APPLICATION FOR PERMISSION
UNDER SECTION 16 OF
THE TOWN PLANNING ORDINANCE
(CAP.131)

擬議臨時商店及服務行業 (日用品及食物零售店)

A/ HSK/405的補充文件

Response to Comments on Temporary Drainage Proposal (Issue 1)

渠道圖

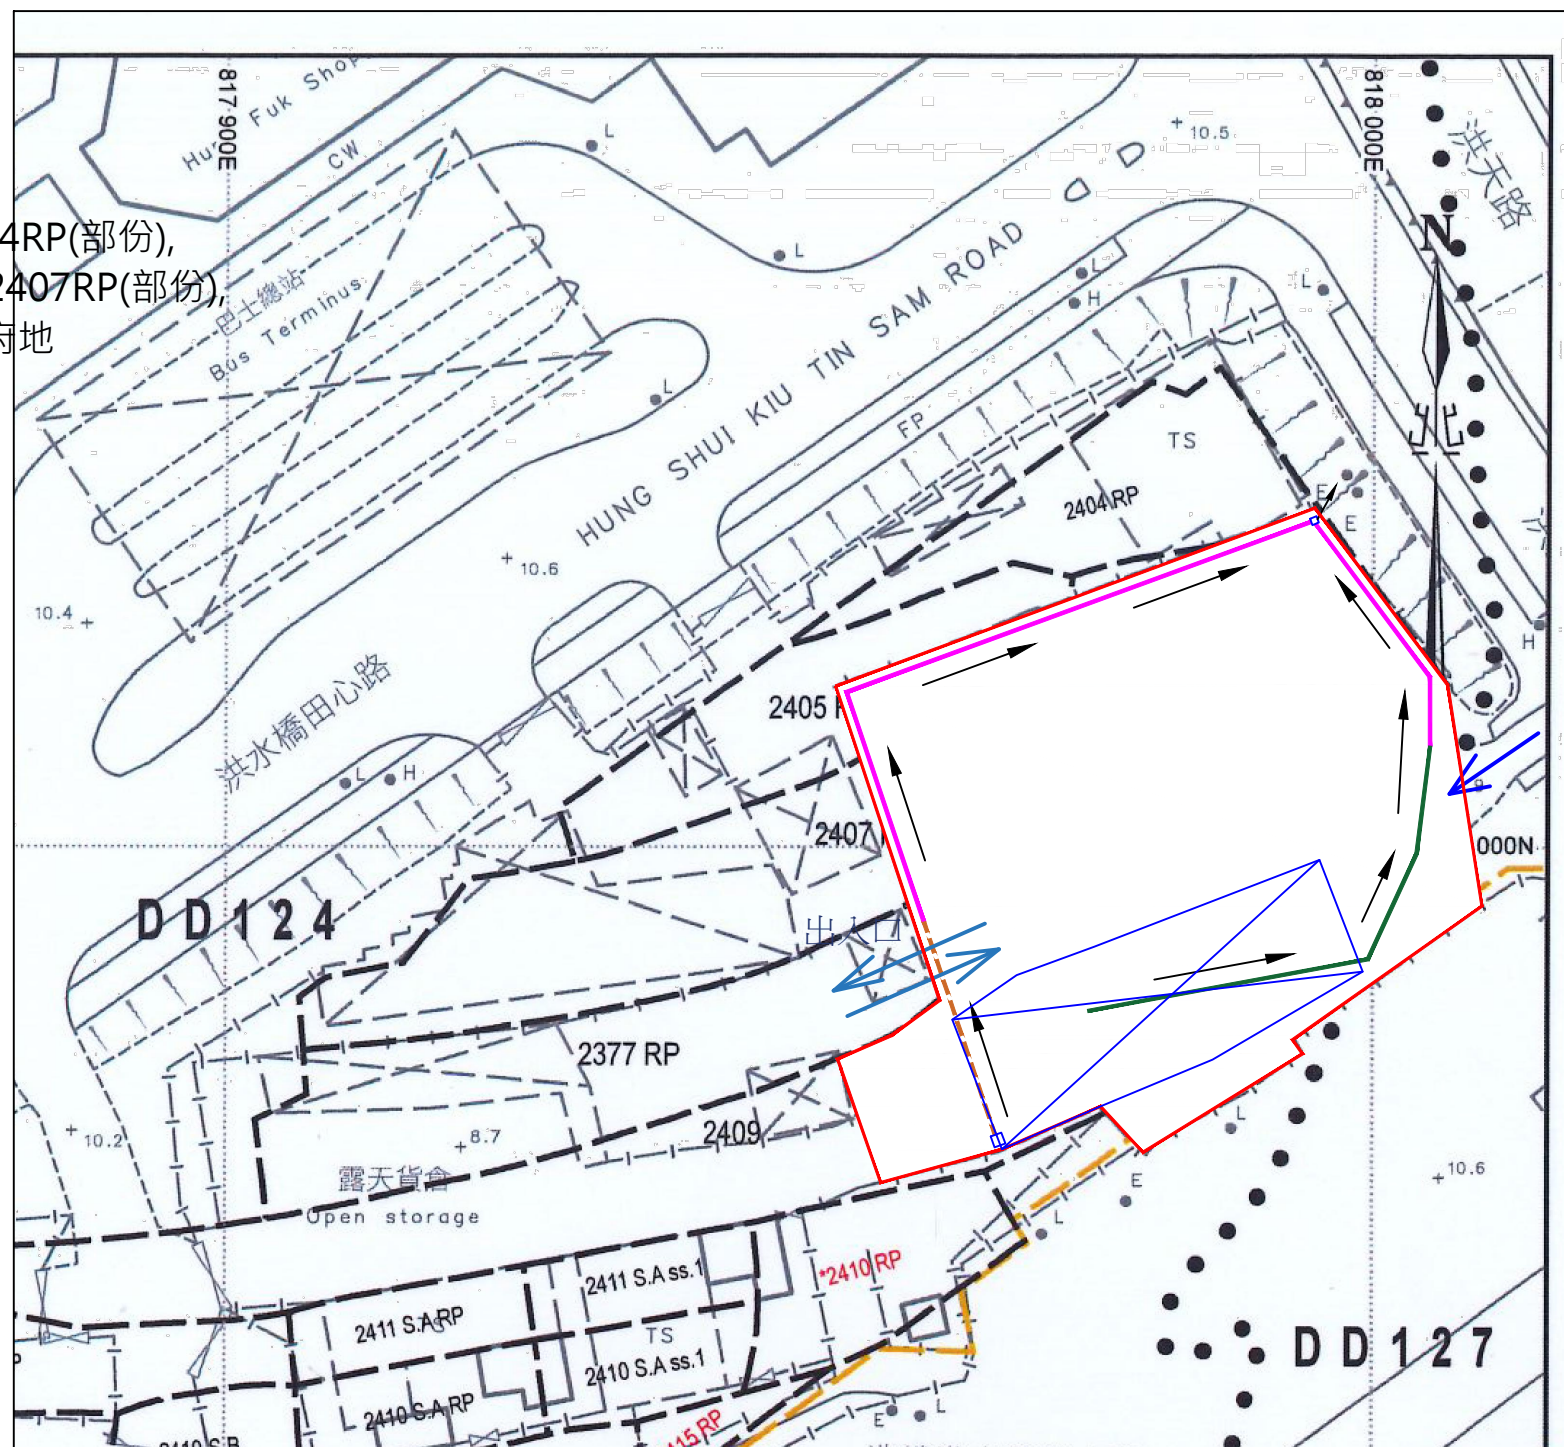
I refer to the your preceding email submitting a drainage plan for the captioned planning application.

Please amend and submit a revised drainage proposal accordingly.

Appendix C - Proposed Drainage Plan

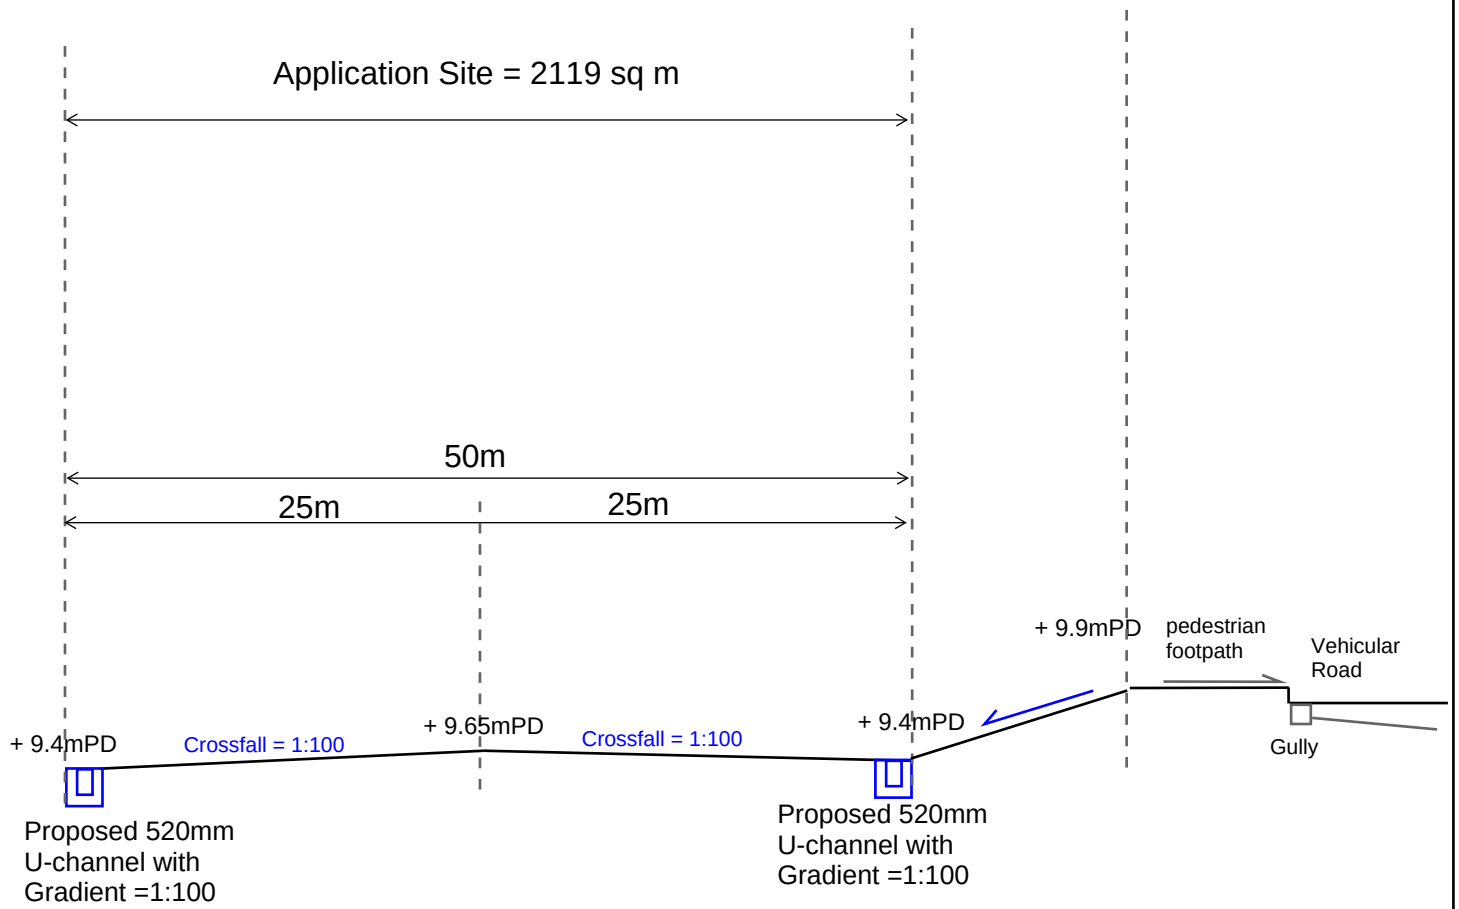
4.	As shown in the drainage plan, the discharge point is a slope feature. Please clarify whether there is a well-established stream course /public drainage system, should it be the case, site photos to demonstrate its presence and existing condition would be required.	The revised discharge point is indicated in the Appendix C.

5.	Please indicate the dimension as well as the gradient of the discharge pipe on drainage plan and demonstrate with hydraulic calculation the proposed discharge pipe has sufficient capacity to convey the surface runoff to the proposed discharge point.	Noted. The proposed 520mm U-channel with 1:100 gradient is indicated in the drainage plan, please refer to the Appendix C. Regarding the hydraulic calculation, please refer to the Appendix D.

6.	The gradients and invert levels of the proposed U-channels should be shown on the drainage plan.	Noted with thanks. The gradients and invert levels of the proposed U-channels had been shown on the drainage plan. Please refer to the Appendix C.

7.	The cover levels and invert levels of the proposed u-channels, catch pits/sand traps should be shown on the drainage plan.	Noted. Please refer to the Appendix C.

No.	Comments	Response
9.	Sand trap or provision alike should be provided before the collected runoff is discharged to the public drainage facilities	Noted and agreed. The terminate catchpit with sandtrap would be provided before connected to the pubic drain. Please refer to the Appendix C.

10.	Consideration should be given to provide catchpit at the turning points of the u-channel	Noted and agreed. The catchpit will be provided at the turning points. Please refer to the Appendix C.
